NUCLEAR REGULATORY COMMISSION

Title: Advisory Committee on Reactor Safeguards
594th Meeting - Open Session

Date: Thursday, May 10, 2012

Overview of the Fuel Storage and Handling System

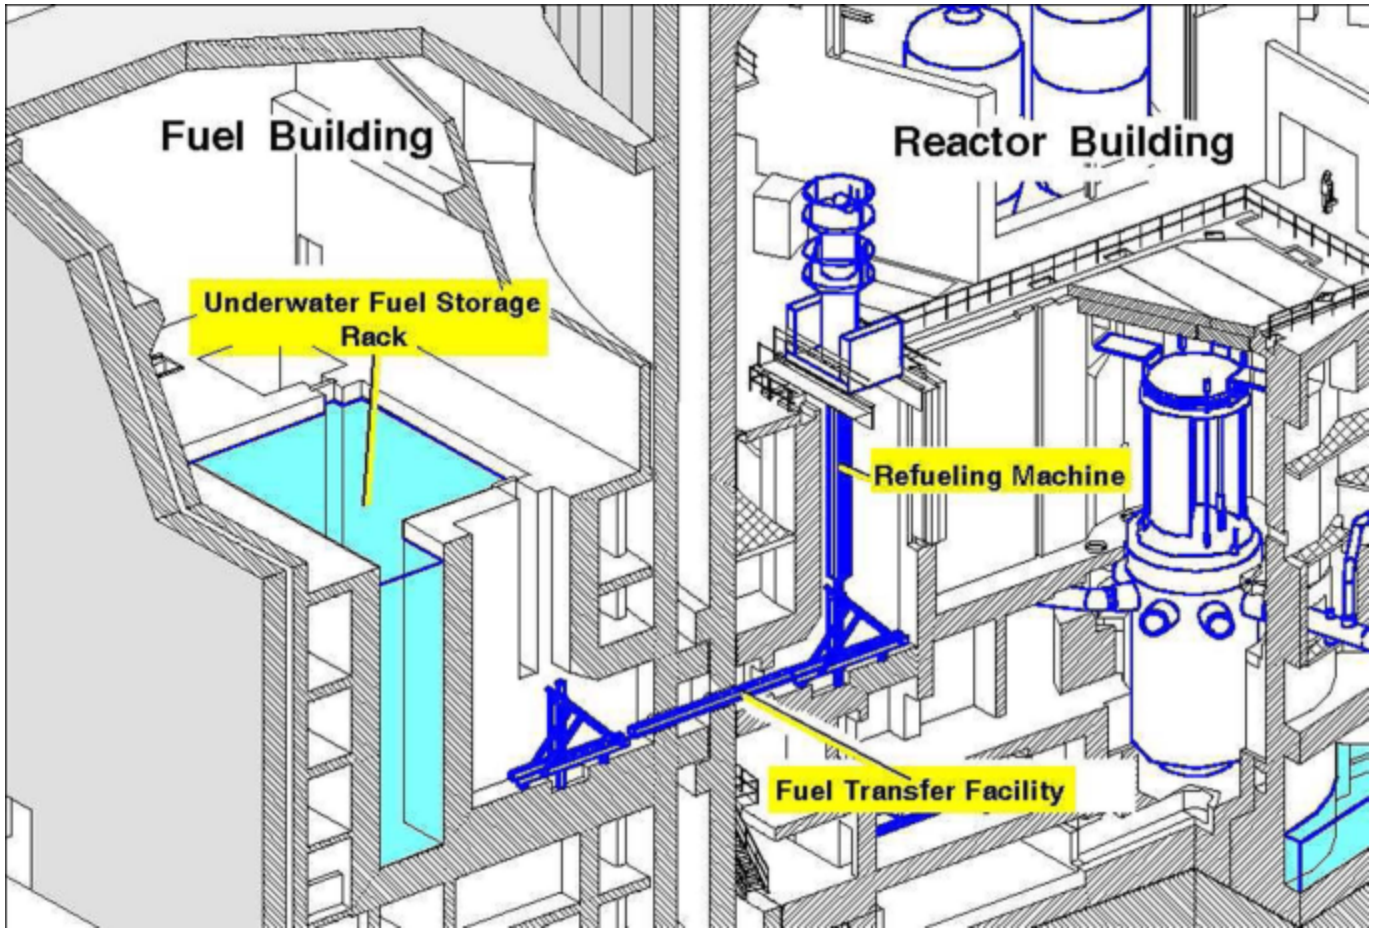
MEMBER SKILLMAN: Show I think the upenders and the transfer rails. And my question is are those operated with pulleys and hoists or are those operated with hydraulics?

MEMBER SKILLMAN: Yes. My real question is whether or not it's mechanical. That is with the motor, pulleys and stainless steel cable or --

MR. PANDYA: This fuel transfer facility is being operated by a conveyer mechanism. It is not like pulleys which is being used in many of the nuclear plants in the U.S. This is sort of a conveyer system. So transfer has a conveyor mechanism inside it and the fuel assembly will be placed on that conveyor. And then it will be transported from one end to other.

Under Pit Spent Fuel Cask Transfer Facility

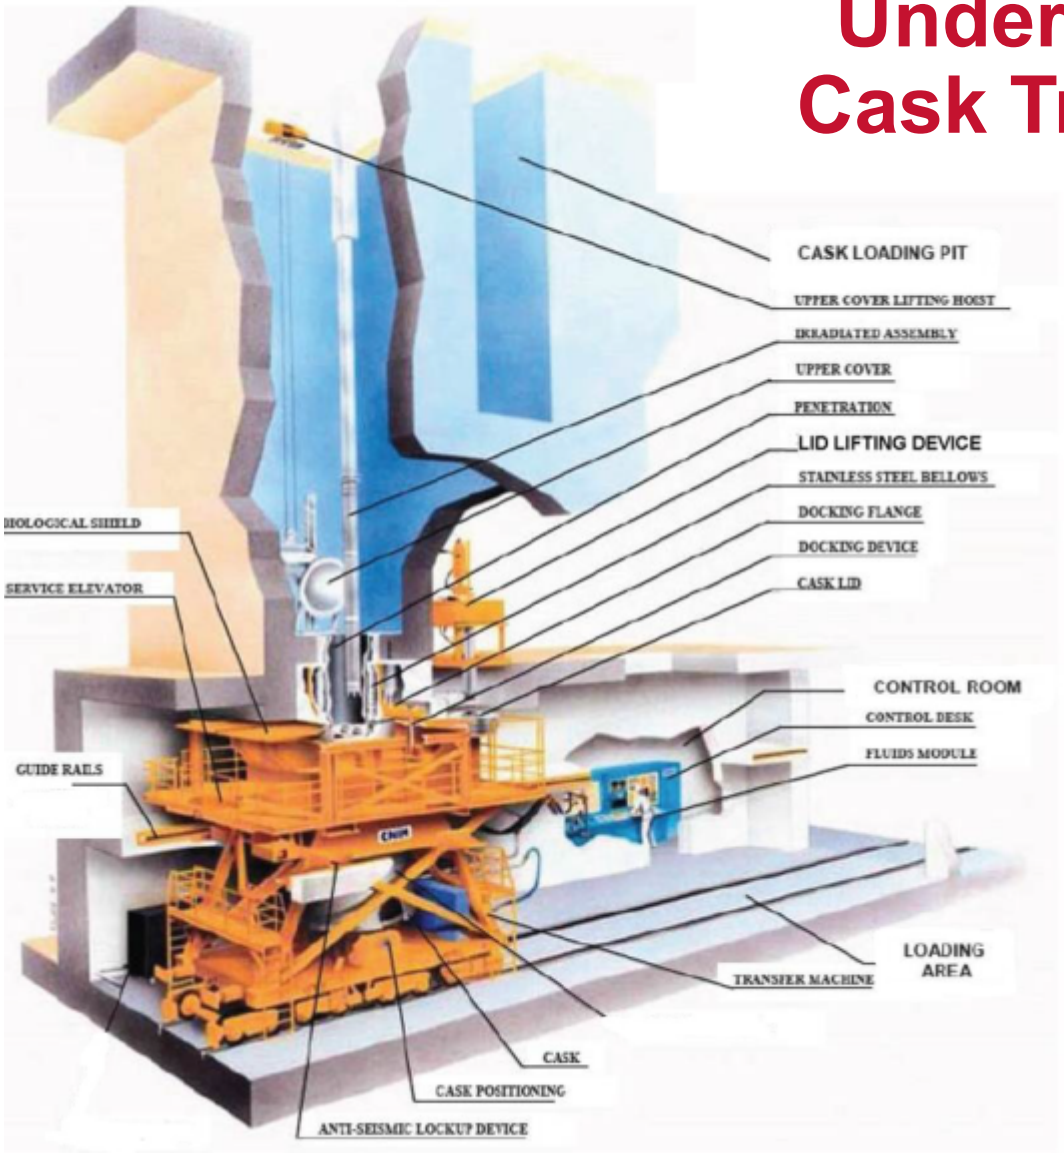
MR. THALLAPRAGADA: Next slide please. This is the under pit of spent fuel cask transfer facility, a schematic of a drawing of how the facility looks like. This is what is unique of what we are trying to present today. This is the first kind in the U.S. It comes from the design -- The basic design comes from plants in France. Sixteen plants or so have this system operating there and we would like to describe which design features in the later slides.

It does this majorly at the upper cover which is on the bottom of the cask loading pit, the penetration itself and its assembly and the lower cover at the lower end of the penetration. The main purpose is to provide a leak-tight connection between the cask loading pit and the internal cavity of the cask.

MR. PANDYA: I would like to add something on your initial question about the vulnerability of the bellow. As far as this design is concerned, there is no really any vulnerable component because this cask transfer machine is anchored to the building wall. So vulnerability --

Platform
Trolley on articulated carriage
Travelling rails

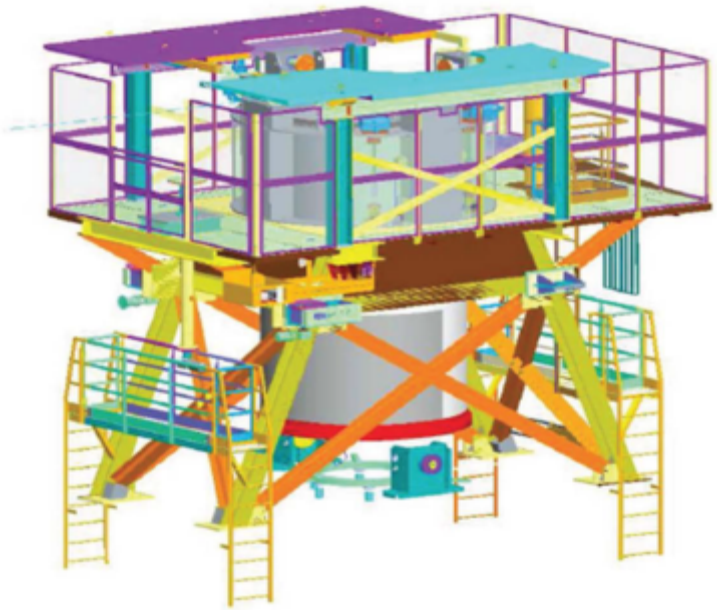
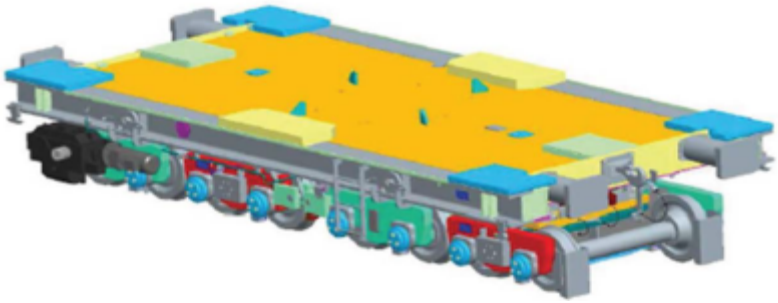
MEMBER BLEY: There's one place I'm still having a little trouble seeing and it's either between your figure nine or 14 I think. You talked about how the cask was anchored. And I can see how it's anchored to those heavy I-beams that are part of the trolley arrangement. How is -- Especially along the axis of the tracks, how is it anchored so as to preclude any motion?

MR. THALLAPRAGADA: On the right-hand side of the figure, you see number two. The two indicates there are anti-seismic devices. There are essentially pins that go into the loading hall. There are holes in the loading hall where these pins would go at every loading station when it's under the handling station

SFCTF Operations in the Fuel Building

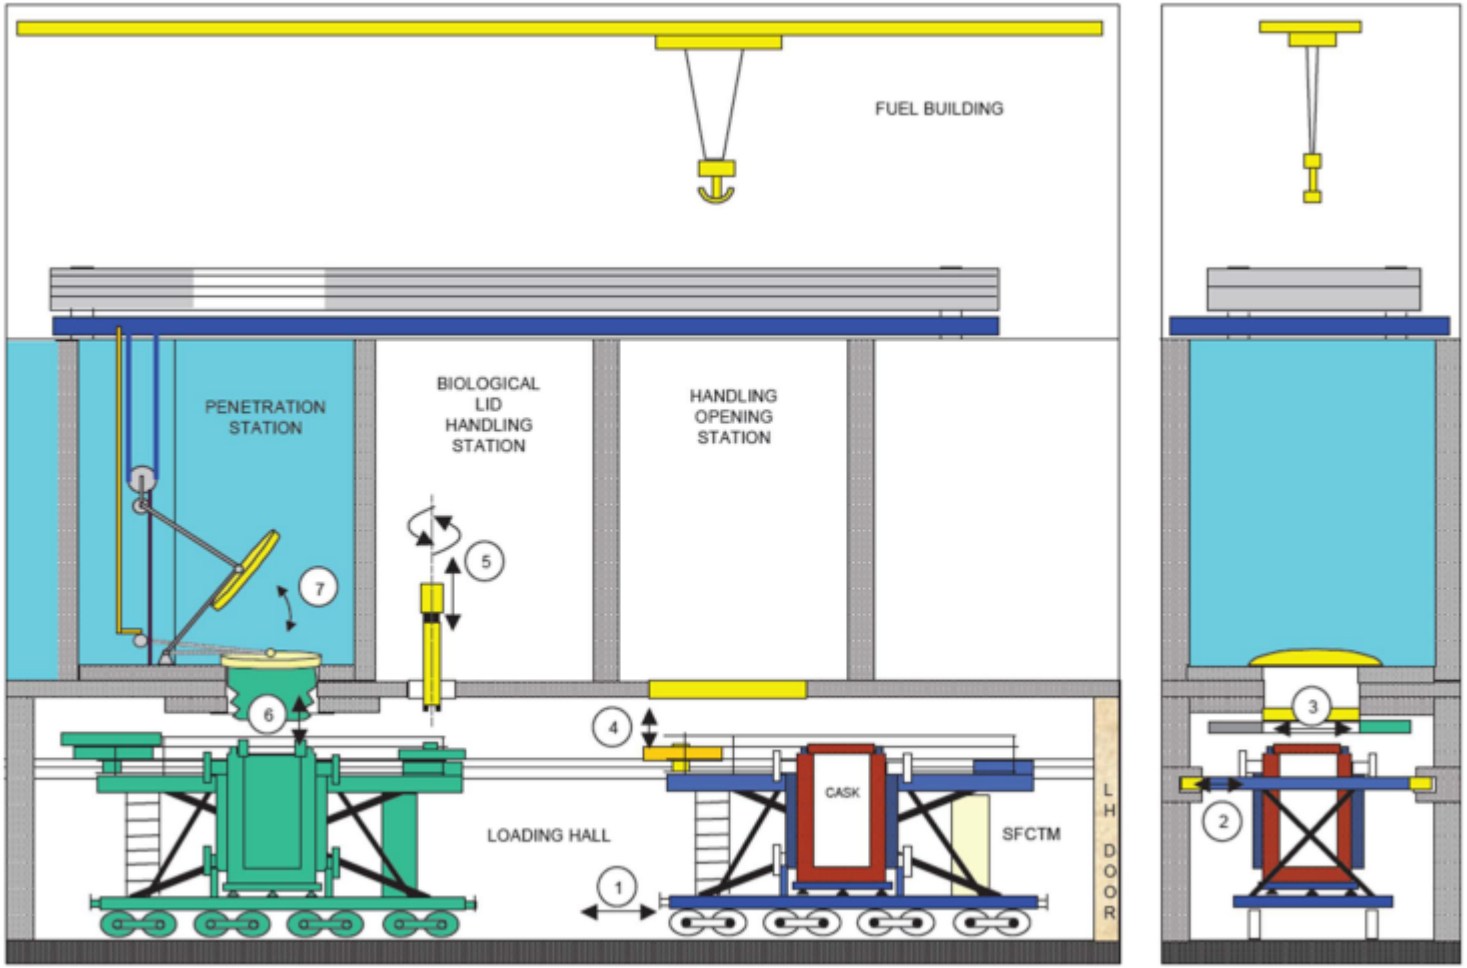
The cask comes through the loading hall door. Do you want to show the loading hall door? Just show it on the picture. The cask essentially -- Yes, that's the loading hall door. It comes from the loading hall and the first station is the handling opening station. That's where the cask essentially is filled. It connected to the electrical and hydraulic sectors in the loading hall. That's the first station.

MR. GARDNER: Yes, and I just want to add a comment, too, for the Members' benefit. We've shown the trolley in only two locations. It's actually stopping as it moves. Okay. We couldn't really show it on this print.
